# Duquesne Light

SUBJECT: Beaver Valley Power Station - Unit No. 2  
Docket No. 50-412  
Identification of Backfit Requirement Number 4

Response to FSAR Questions 430.97 and 430.100

FIG. RESPONSE 8.12(2)-3  
**AIR STARTING SYSTEM**  
BEAVER VALLEY POWER STATION-UNIT 2  
PRELIMINARY SAFETY ANALYSIS REPORT

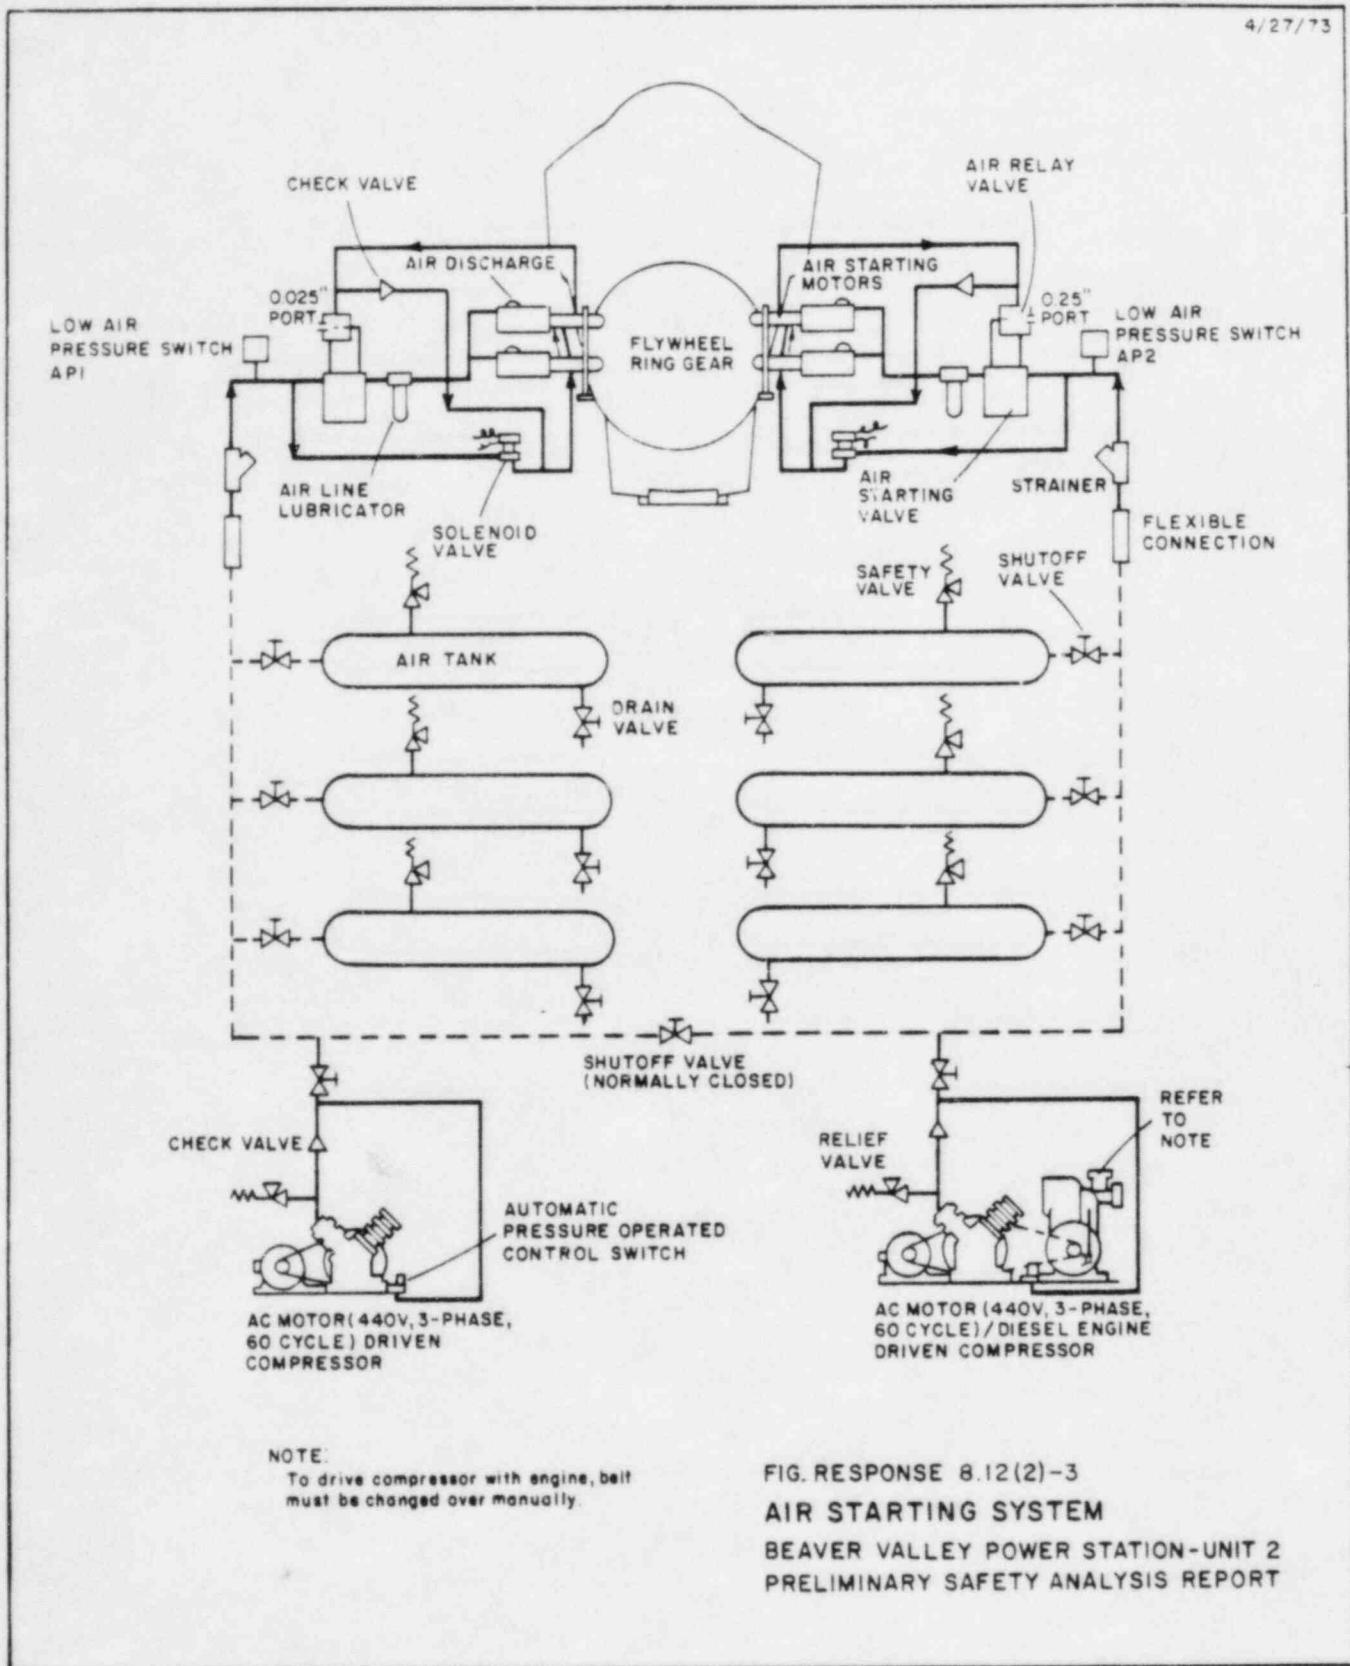
In an effort toward improving diesel engine starting reliability, we require that compressed air starting system designs include air dryers for the removal of entrained moisture. The two air dryers most commonly used are the desiccant and refrigerant types. Of these two types, the refrigerant type is the one most suited for this application and, therefore, is preferred. Starting air should be dried to a dew point of not more than 50°F when installed in a normally controlled 70°F environment, otherwise, the starting air dew point should be controlled to at least 10°F less than the lowest expected ambient temperature.

Revise your design of the diesel engine air starting system accordingly, describe this feature of your design. Also expand your FSAR to discuss the procedures that will be followed to ensure the dryers are working properly and the frequency of checking/testing (SRP 9.5.6, Parts II and III).

The University of Dayton study which concluded that water accumulation was a leading cause of diesel starting failures was based upon analysis of Licensee Event Reports (LER) issued from 1969 through 1977. Improvements in industry practices since that time, and the success of such practices must also be considered. During the first year of operation (1976-1977) at BVPS-1, two failures of the diesel generators to start because of moisture were reported via LER. To prevent further occurrences, a system of periodic blowdown as well as blowdowns prior to testing was implemented. No moisture related start failures have occurred which resulted in LER's in the seven years since (approximately 1/6 of the expected plant life). In addition, a more recent study by the Institute for Nuclear Power Operations used 450 diesel related LER's issued since January 1980 to analyze failure data. This study shows that only 5% of the more recent failures were due to moisture. Improved operation and maintenance practices applied by the industry when the moisture problem first became apparent on an industry-wide basis in the late 1970's is undoubtedly part of the reason for this improvement. Such practices at BVPS-1 have proven to be highly successful.

As described in FSAR 9.5.6, the method of starting the diesels used at BVPS-2 involves admission of air directly into the engine's cylinders. This eliminates the need for air start motors used on some other designs which are, as stated in NUREG/CR 0660, more susceptible to moisture related damage. Another important design feature which allows these diesels to be more tolerant of any starting system failure is the redundancy of the start systems. Each diesel is provided with redundant starting system components to enhance its starting reliability as stated in FSAR 9.5.6.

In accordance with GDC 17, sufficient independence and redundancy is provided to assure performance of safety functions assuming a single failure. Loss of a single diesel generator is considered in the safety analyses. As demonstrated at BVPS-1, loss of a diesel due to moisture is a rarity when appropriate operating and maintenance practices are applied. Coincident loss of both diesels due to moisture would be even less likely and is prevented in part by the independence of the air starting systems.

The use of operating procedures similar to those in use at BVPS-1 should provide diesel reliability similar to that of BVPS-1. Additionally, periodic testing will confirm the availability of the diesels. Thus, it cannot be concluded that installation of the air dryers, as requested by the NRC, would provide substantial additional protection which is required for the public health and safety. Therefore, this proposed backfit is not justified under 10CFR50.109.
